January 23, 1991

Ref: Docket No. 70-398
License No. SNM-362

RESPONSES TO QUESTIONS POSED BY USNRC IN SNM-362 LICENSE RENEWAL REVIEW

(from letter of 12/17/90)

Figure 2: Environmental Water Sample Locations

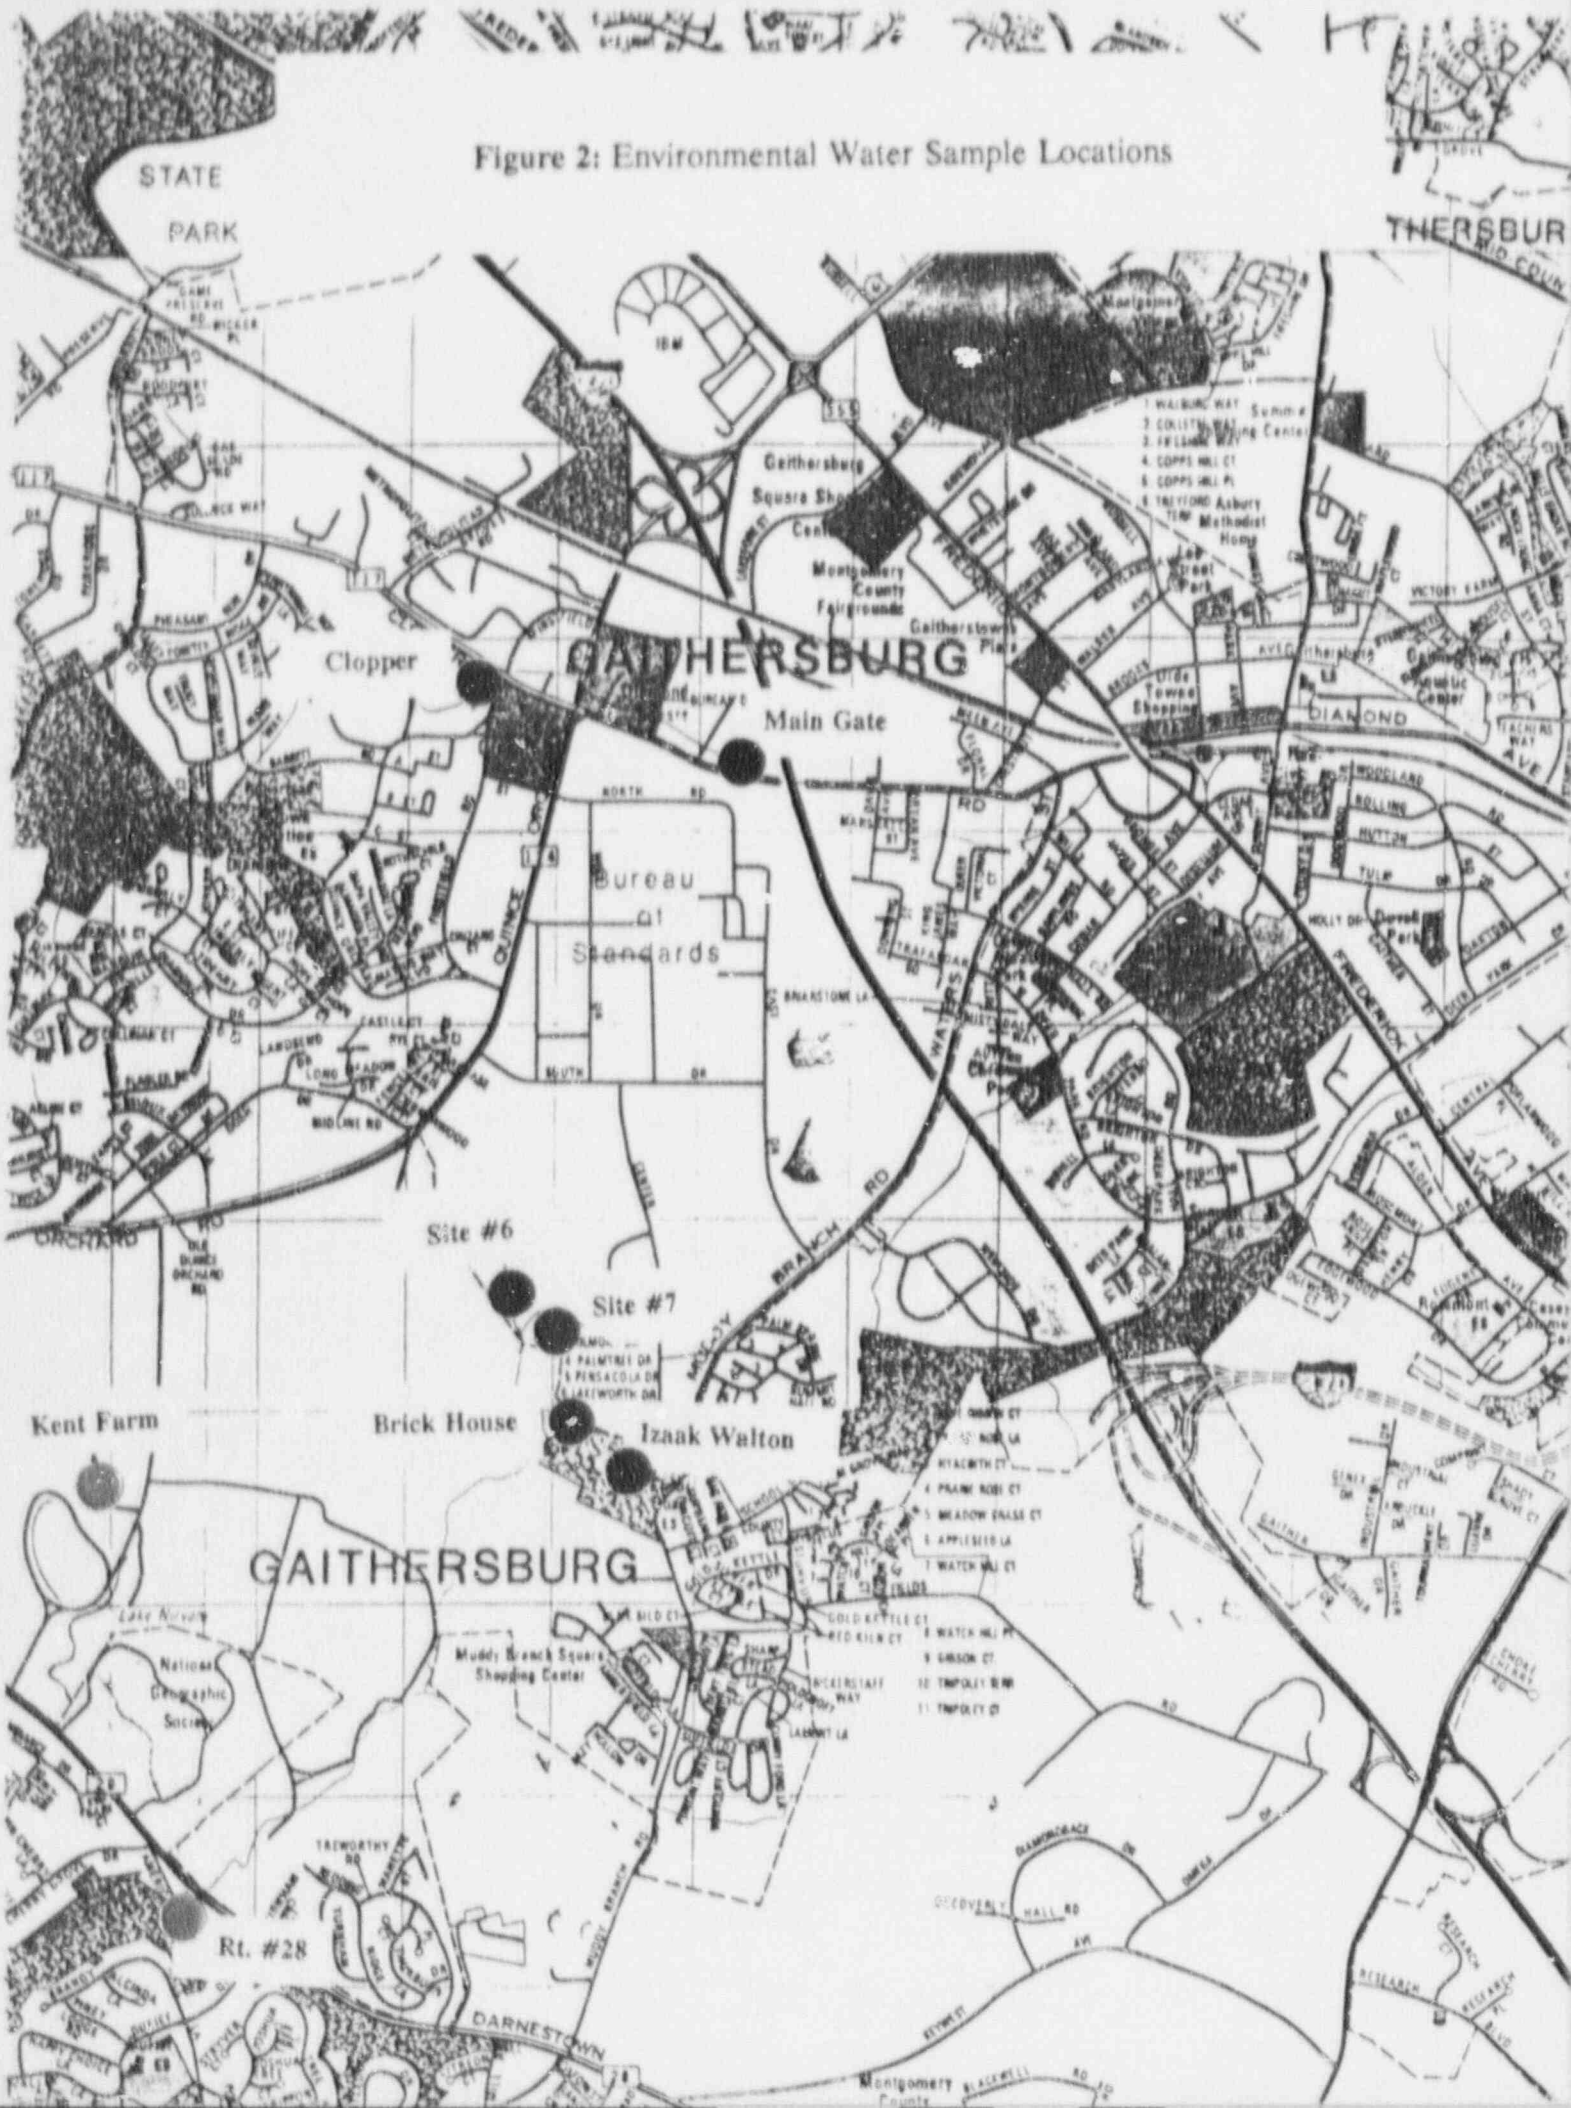
- 6... *Provide a map showing environmental sampling locations.*

A map showing environmental sampling locations is appended to this document as Figure 2.

Figure 2.5 Annual wind rose

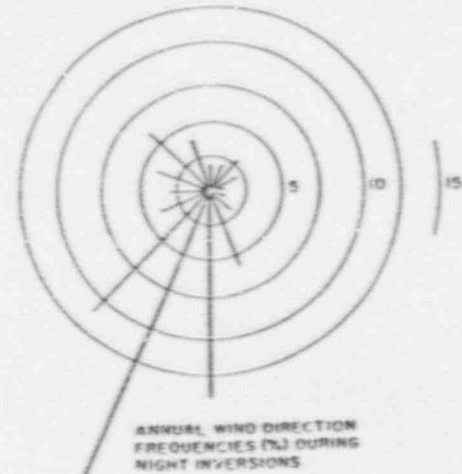
10... *Provide information on the average meteorology for site.*

This data is published in NUREG-1007 and NBSR-9 and continues to be current. Figure 2.5 from NUREG-1007 and Table 2.3 from NBSR-9 are appended.
